REVISED RESPONSE TO REQUEST FOR ADDITIONAL INFORMATION

APR1400 Design Certification

Docket No. 52-046

RAI No.: 141-8098
SRP Section: 12.03-12.04 - Radiation Protection Design Features
Application Section: 12.3
Date of RAI Issue: 08/07/2015

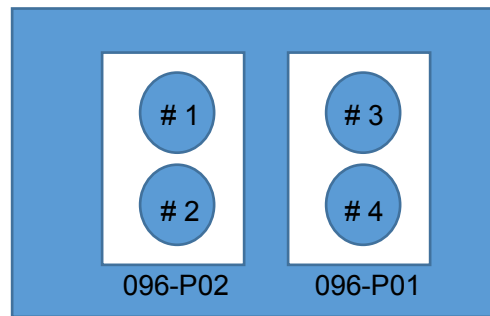
3. While the FSAR indicates that there are four gaseous radwaste system delay beds, it is unclear which rooms each delay bed is located. FSAR Table 12.3-4 indicates that Rooms 096-P01 and 096-P02 are delay bed rooms. Please specify in the FSAR which rooms each of the delay beds (1, 2, 3, and 4) are located.

2. As shown in DCD Figure 12.3-12, Room 063-P05 is the Spent Resin Long-term Storage Tank Room, and Room 063-P06 is a room for "Future Use". Therefore, Table 12.3-4 will be updated to correct this discrepancy.
3. Two delay beds are located in a cubicle. The first and second delay beds are located in Room 096-P02, and the third and fourth beds are in Room 096-P01 as below;
